Published date	12/12/2018
Document number	SUPAIR_2018/12/002
Page number	1 / 2

Safety info

SUBJECT : ACRO BASE harness

Lateral adjustment straps tear

Facts/ Ascertainment :

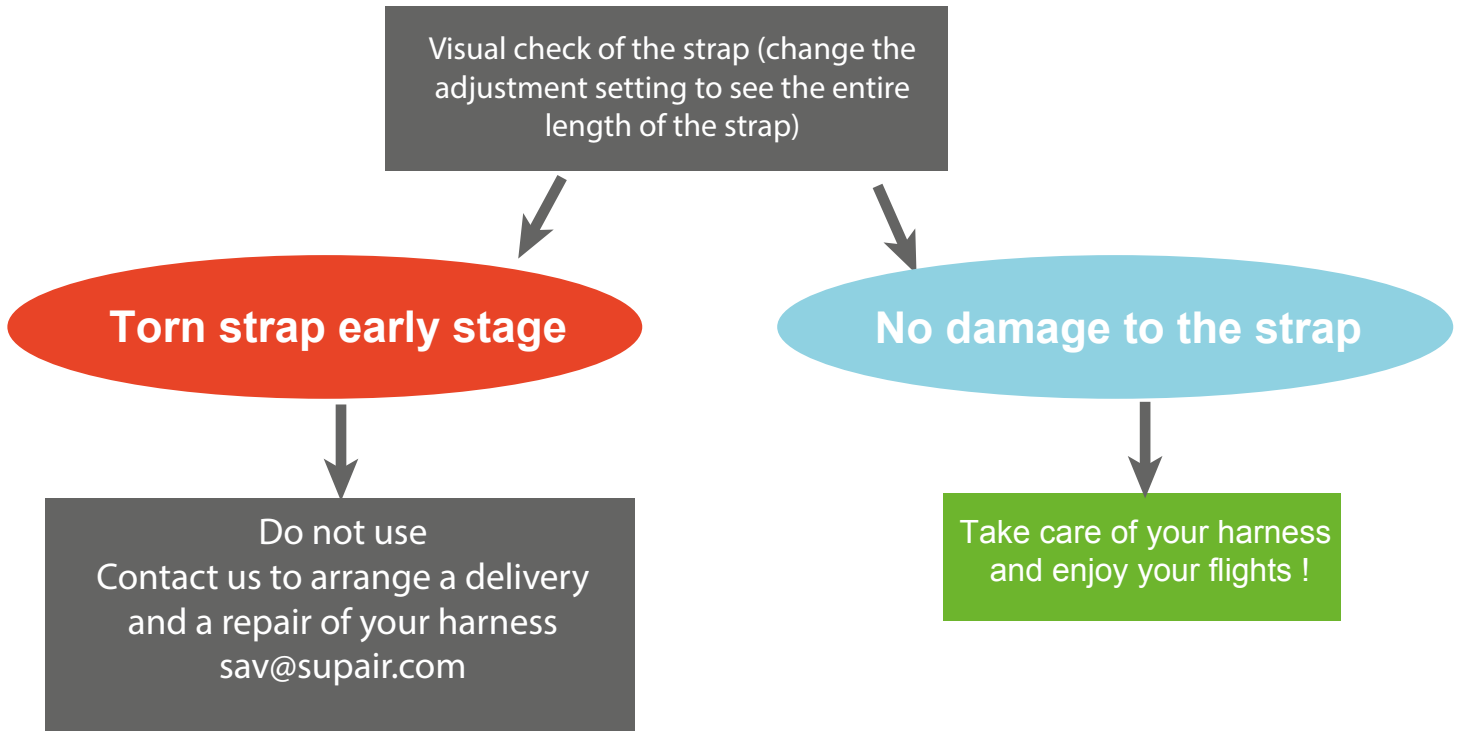
Caution, the side backrest adjustment strap (higher one) may be damaged in the adjustment buckle.

The upper lateral backrest tilt adjustment strap might start to tear during use. This tear can lead to a complete rupture of the strap. This specific strap does not affect the harness' structure but might impact the support of the pilot, making the harness uncomfortable especially if the second adjustment strap is not set properly.

This can also lead to a lack of position awareness and support of the pilot and might have consequences on certain phases of flight.

DELAIS : The inspection must be done immediately
